Decommissioning, Demolition and Site Restoration SSB HQ – Southside Road, St. John’s, NL EA003-221976/A

AMENDMENT # 2

ADDENDUM NO. 1

DEMOLITION SITE PLAN

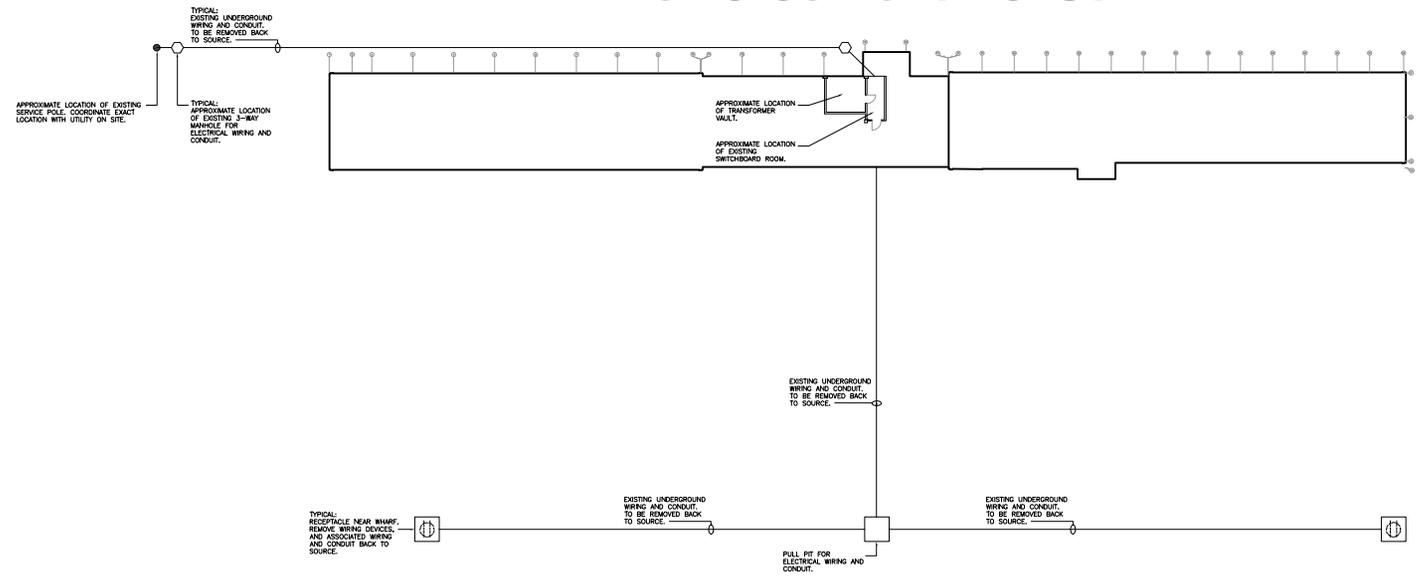
Delete drawing E2 – issued for tender 12/16/21 and replace with revised drawing E2 issued for addendum #1 dated 02/09/22, attached.

THESE DRAWINGS REPRESENT THE ORIGINAL ELECTRICAL DESIGN FOR THE BUILDING AND MAY NOT BE TOTALLY ACCURATE OR REFLECT SITE CONDITIONS. ALL POWER PEDESTALS LOCATED ON THE WHARF ARE CURRENTLY FED FROM A DETACHED ELECTRICAL BUILDING ON THE PROPERTY AND SHALL REMAIN. DELETE ALL REFERENCE ON THESE DRAWINGS TO REMOVING WIRING, CONDUIT AND POWER PEDESTALS.
